## Response to Submissions Report

‘Pathways Leura Village Seniors Housing’  
(SSD-80068720)

203-223 Leura Mall, Leura

5 February 2026

Figure 2: Ground floor plan – as lodged (Source: PBD)

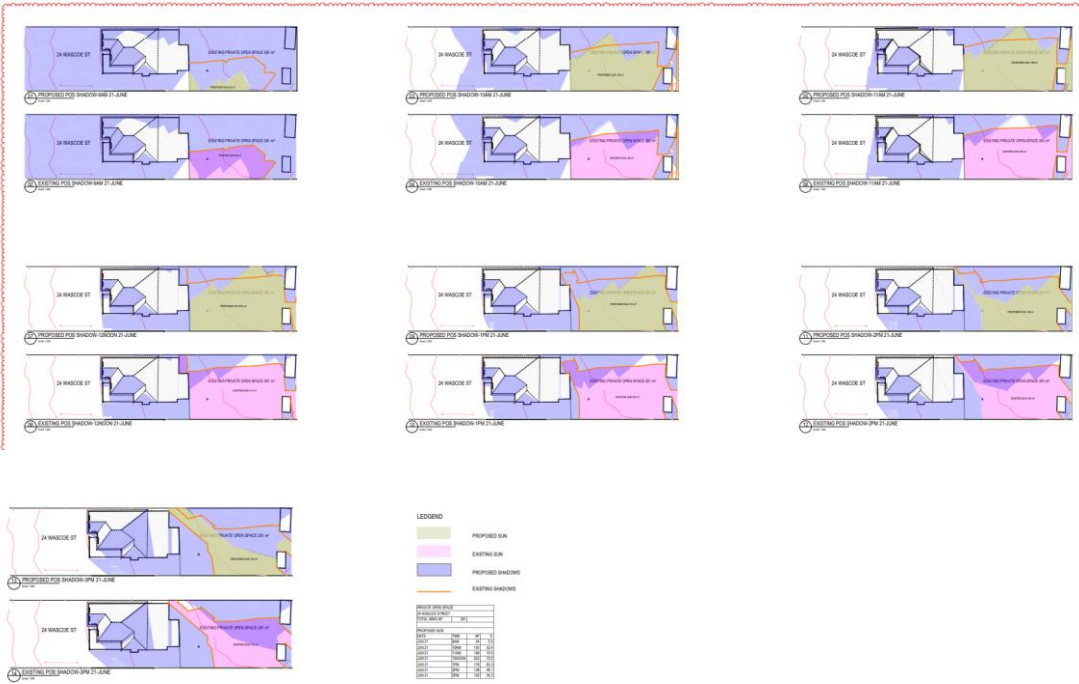
DPHI Raised Issue	Response	Relevant report(s)
<p><b>1. Amenity impacts to southern properties</b></p> <p>The proposed development creates unacceptable amenity impacts on neighbouring properties to the south, in particular the property at 24 Wascoe Street. The proposed southern setback, building height, topography of the land and the removal of existing vegetation on the southern boundary, results in significant overshadowing, visual privacy and visual impact to the residential properties to the south.</p> <p>Specifically, the development has been designed with 36 residential care facility (RCF) rooms directly overlooking 24 and 26 Wascoe Street and the overshadowing diagrams submitted demonstrates that 24 Wascoe Street will not receive a minimum of 2 hours solar access between 9am and 3pm on 21 June (mid-winter).</p> <p>While it is acknowledged the site's existing heritage, built form and topography create constraints. The Department considers the development's exceedance of building height and floor space ratio (FSR) (see point 2 below) changes are not justified. Design changes are required to reduce the bulk and scale of the development to make sure the development does not adversely impact the amenity of</p>	<p>Following receipt of DPHI's comments, the Proponent and project team re-grouped to test multiple design changes which would yield an improvement to the amenity of the properties to the south, namely no. 24. These scenarios sought to improve overshadowing impacts, particularly to no.24's rear POS and better manage overlooking.</p> <p>PBD utilised the existing baseline as the starting point, then made a comparison to the originally submitted proposal. It was evident that certain portions of the saw-tooth design, at the south elevation were causing adverse overshadowing and their associated small balconies orientated south contributed to overlooking.</p> <p>To address this, PBD has internally replanned of the south-west corner of the new west wing to delete two rooms, pull back portions of the south-west corner to improve access to sunlight for the properties to the south and half the number of rooms orientated to the south and amendment to the originally proposed trafficable balcony and introduction of juliet balconies therefore addressing overlooking. This can be seen in the following comparison images.</p> 	<ul style="list-style-type: none"> <li>• Revised Architectural Drawings (Appendix 7)</li> <li>• Revised Architectural Design Report (Appendix 8)</li> </ul>

DPHI Raised Issue	Response	Relevant report(s)
<p>neighbouring properties. This includes:</p> <ol style="list-style-type: none"> <li>increasing the setback to the south to reduce the adverse impacts to the surrounding properties</li> <li>achieving a minimum 2 hours of direct solar access between 9am and 3pm on 21 June to the principle private open space of 24 Wascoe Street, and there is to be no increase in the shadow produced from the existing development</li> </ol>		
	<p><b>Figure 3: Ground floor plan – proposed amendment (Source: PBD)</b></p> <p>In relation to DPHI's comment 1(a), the southern setback to no.24 as originally proposed was a minimum of 2.49 metres and has increased to a minimum of 3.7 metres (measures from the southern setback to the edge of the proposed Juliet balconies).</p> <p><u>As lodged:</u></p>  <p><u>Modified proposal:</u></p>
